THE LEXINGTON II
KOMO MASTER PLAN

SHEET TITLE
FOUNDATION PLAN

SHEET NUMBER
S100

1 FOUNDATION PLAN
SCALE 1/4" = 1'-0"

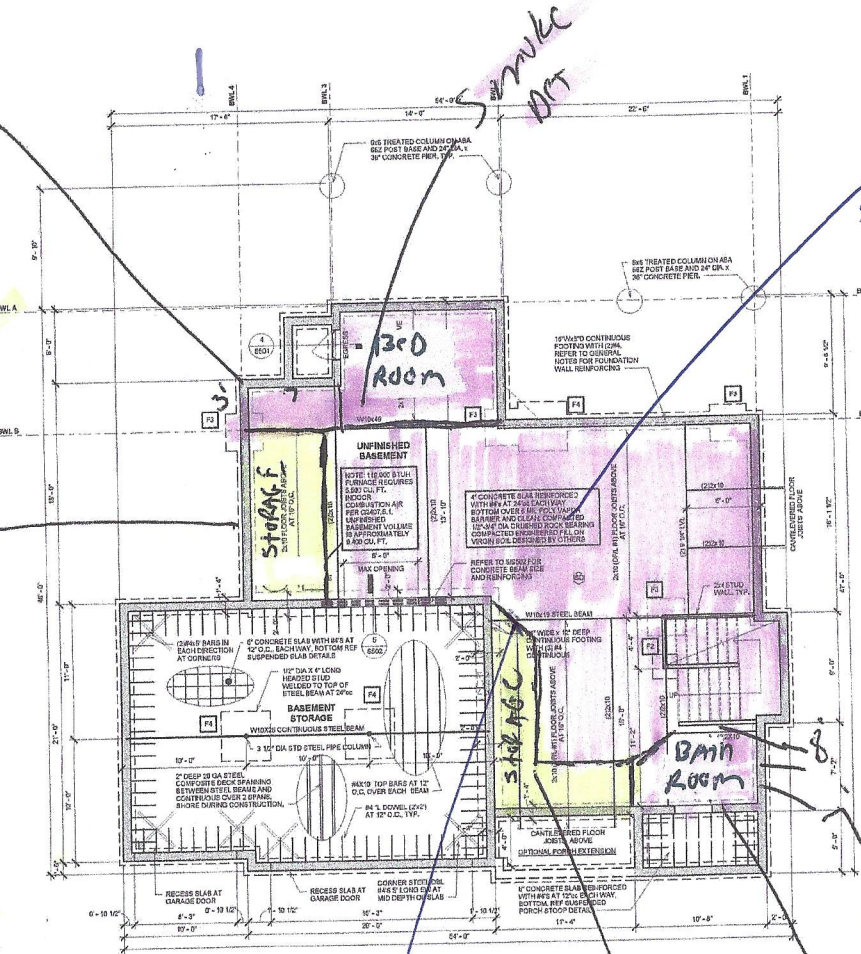
closet
3x7

yellow = storage

good square foot
basement finish

Return Air

Smoke Det
